SUBSURFACE WASTEWATER DISPOSAL SYSTEM APPLICATION

Town Or Plantation	AUGUSTA
Street division Lot #	OFF WEEKS MILLS ROAD; FOX GLEN, LOTS 109, 110, 111, 353, 354, 10-320, 10-321

Revised design for Permit #1930 issued 8.7.90

SUBSURFACE WASTEWATER DISPOSAL PLAN

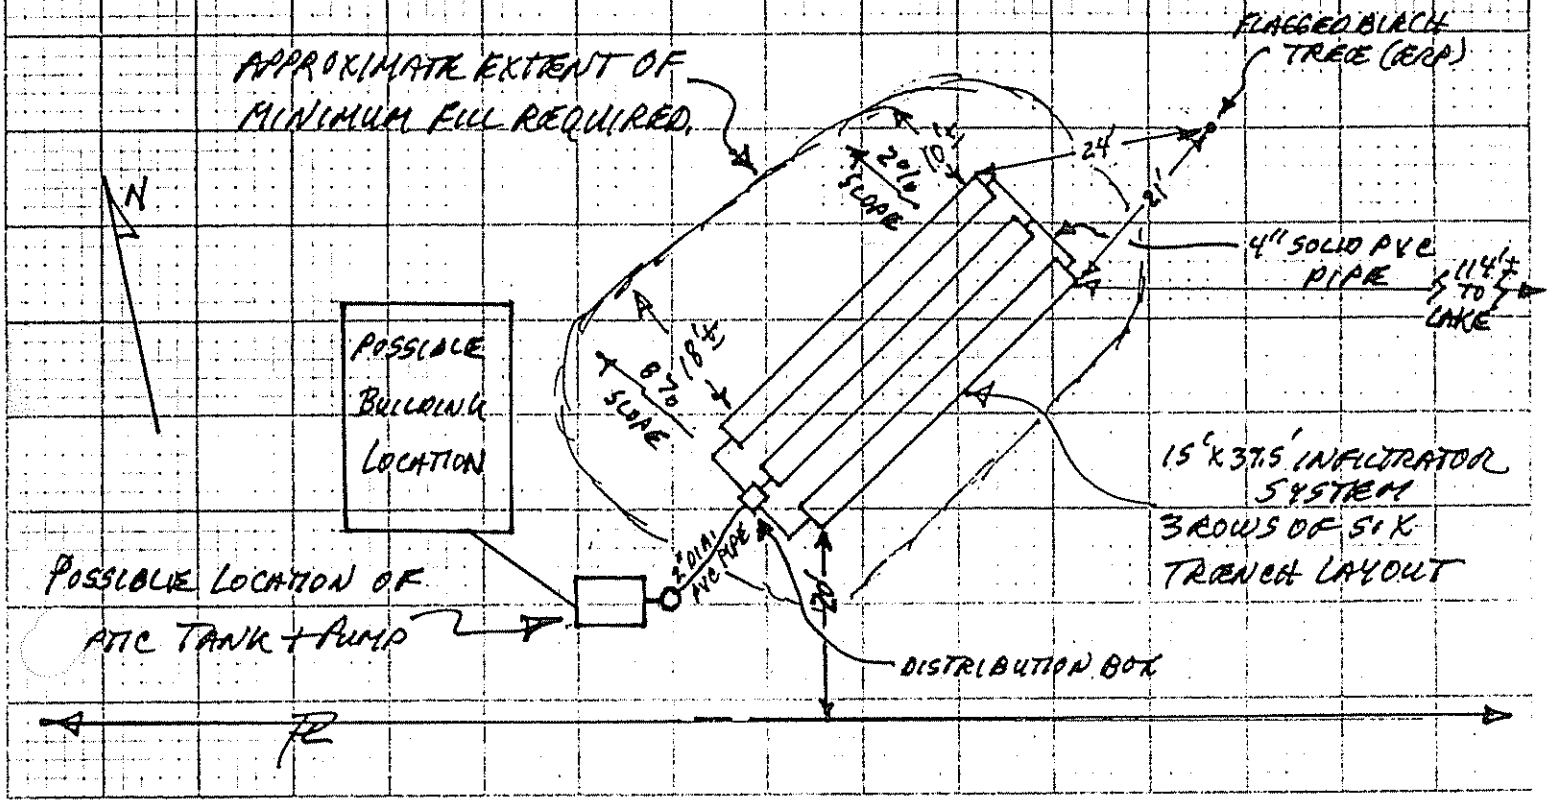
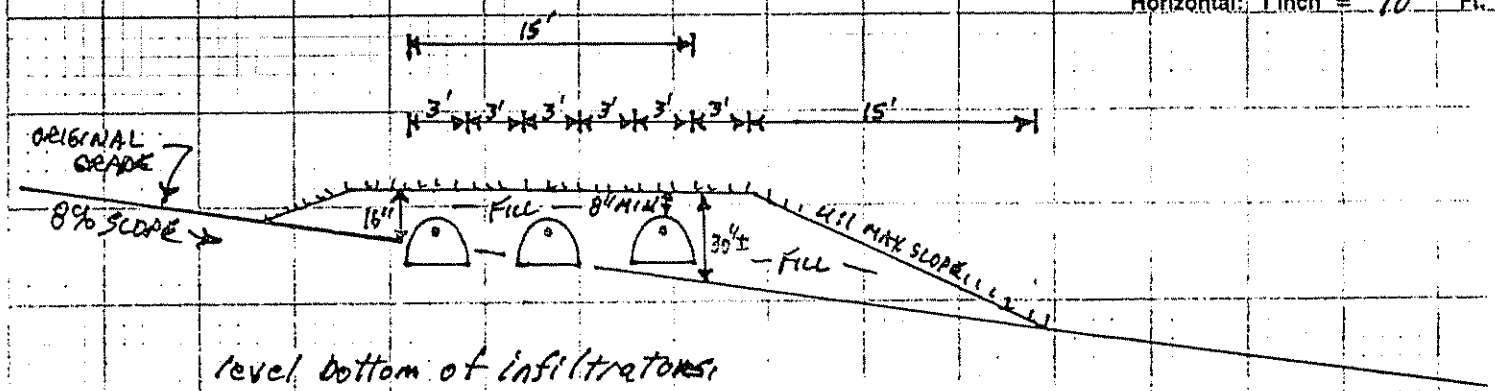
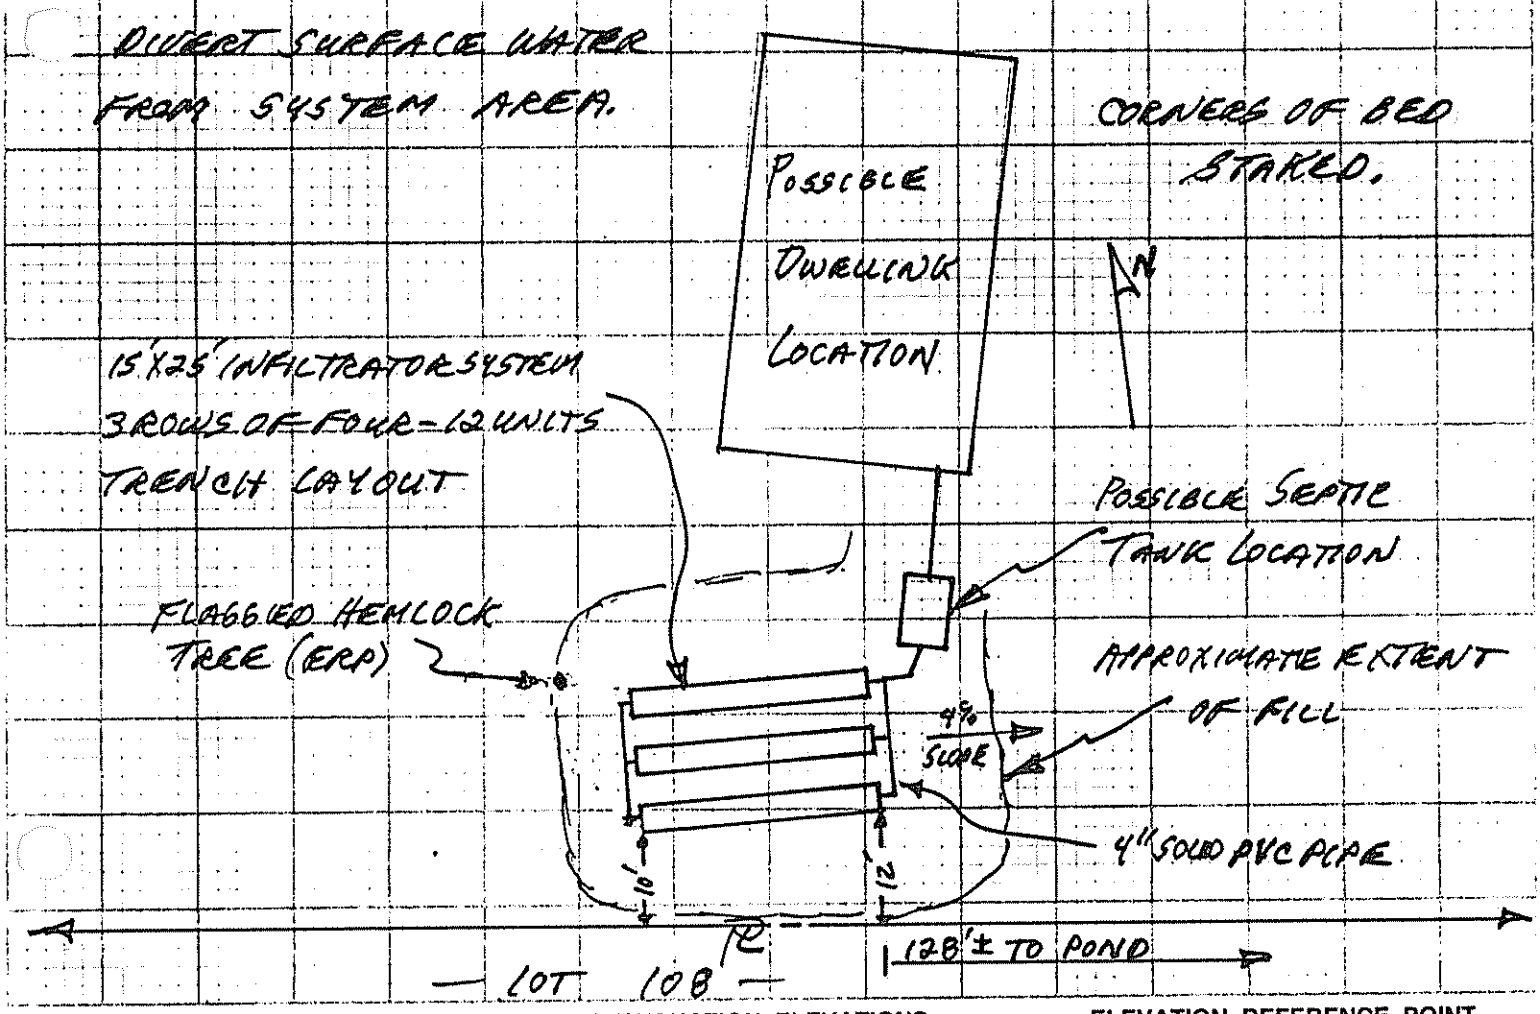
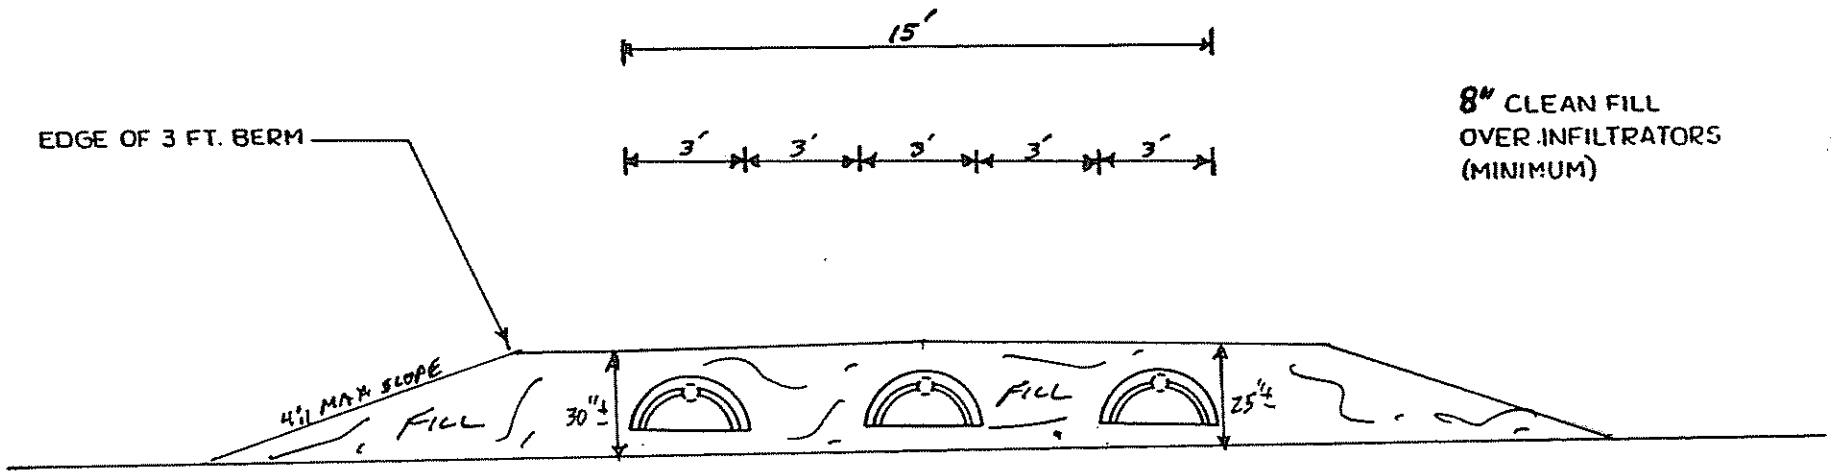
SEE REVISED DESIGN ATTACHED

CRITERIA USED FOR DESIGN FLOW (BEDROOMS, SEATING, EMPLOYEES, WATER RECORDS, ETC.)
2 BEDROOM SINGLE FAMILY DWELLING
DESIGN FLOW: 180 (GALLONS/DAY)

DISPOSAL AREA TYPE/SIZE
1. ☐ BED _____ Sq. Ft.
2. ☒ CHAMBER 375 Sq. Ft.
☒ REGULAR ☐ H-20
3. ☐ TRENCH _____ Linear Ft.
4. ☒ OTHER: ~~ZIN ALTERNATOR~~ 3 MAYS OF FOUR

Depth of Fill (Upslope) 18"
Depth of Fill (Downslope) 25 TO 30±

Reference Elevation Is 0
Bottom of Disposal Area -43"
Top of ~~Distribution Lines or Chambers~~ INFILTRATORS -28"

1. REMOVE VEGETATION AND SCARIFY ORIGINAL SOIL UNDER INFILTRATORS AND FILL EXTENSION AREAS.
2. BOTTOM OF INFILTRATORS TO BE LEVEL WITH A MAXIMUM GRADE TOLERANCE OF 1" PER 100'.
3. PROVIDE FOR SURFACE DRAINAGE AWAY FROM INFILTRATOR AREA.
4. FINISHED GRADE SHALL BE SEEDED AND MULCHED TO PREVENT EROSION.
